OCT-21-1996 10:33 A I W 1 401 723 3580 P.02/03
FORM FOR PROPOSALS FOR 1999 NATIONAL ELECTRICAL CODE

FORM FOR PROPOSALS FOR 1999 NATIONAL ELECTRICAL CODE

2856-2

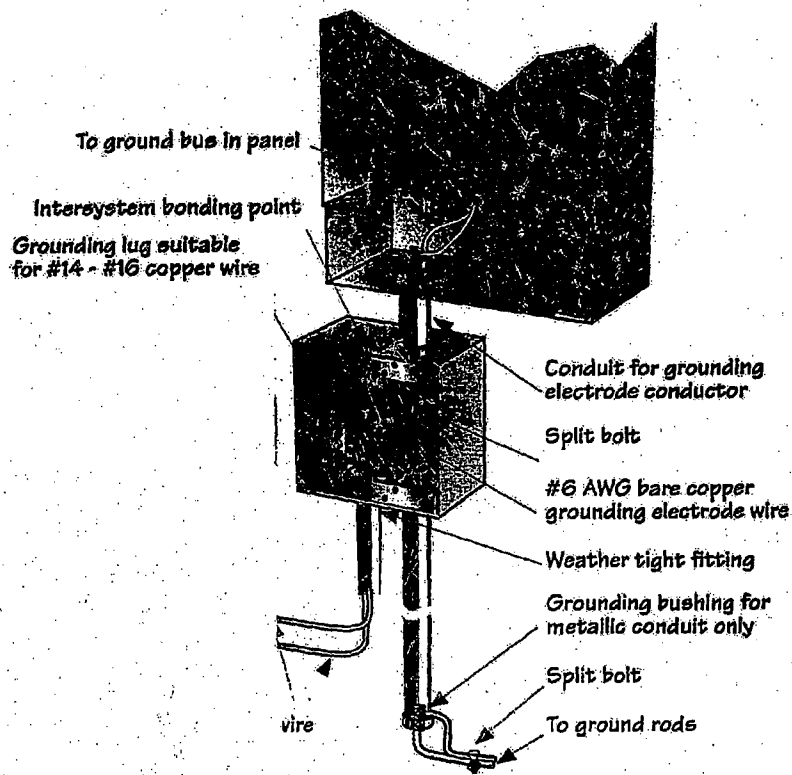
- (1) NO CHANGE
- (2) NO CHANGE
- (3) NO CHANGE

4. Statement of Problem and Substantiation for Comment:

Revise as follows:
